UNITED STATES PATENT AND TRADEMARK OFFICE

10/723,126

| Office Action Summary | Application No. 10/723,126 | Applicant(s) GILBREATH, DONALD R. | |

DETAILED ACTION

the collar support portion an axial stop ring (see Figure 6 below),

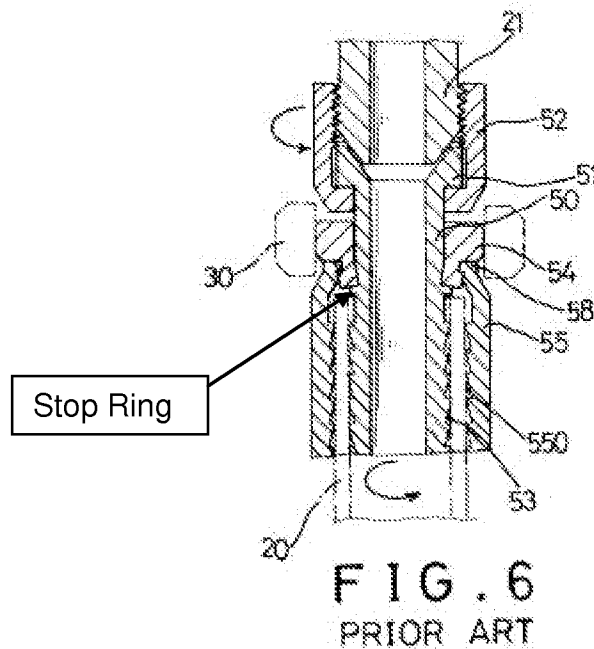
In regards to claims 1 and 2, Huang discloses an improved hydraulic fitting having a stem (50) including a hose insert portion (53), and a collar support portion, having a mating connection portion (50, 51), and a collar having (54), a torque communication portion, a female support portion, and an inner periphery having a non-threaded knurling mating surface extending through the ferrule support portion and the torque communication portion, the improvement comprising:

the torque communication portion of the collar staked in such a manner that the inner periphery non-threaded knurling mating surface extending through the torque communication portion communicates in a relatively non-rotational manner, and

the ferrule support portion of the collar staked in such a manner that the inner periphery extending through the ferrule support portion engages the axial stop ring in an axial movement limiting manner.

Huang teaches splines stem, but does not disclose the collar support portion including knurling. Le Clair teaches a collar support portion including knurling (6), “to provide improved couplings and improved methods for attaching couplings to hoses” (col. 1, lines 21-23). As Le Clair relates to coupling of the kind which comprises a ferrule at one end, it would have been obvious to one having ordinary skill in the art at the time the invention was made to provide the collar support portion including knurling, to

Huang does not teach away from the supplantation of the structure shown in Prior Art Figure 6 with the structure shown in Figures 1-4.

Further, the Examiner is not substituting splines for knurling; the Examiner is incorporating/providing knurling into Huang's Prior Art Figure 6 to improve couplings and methods for attaching couplings to hoses.
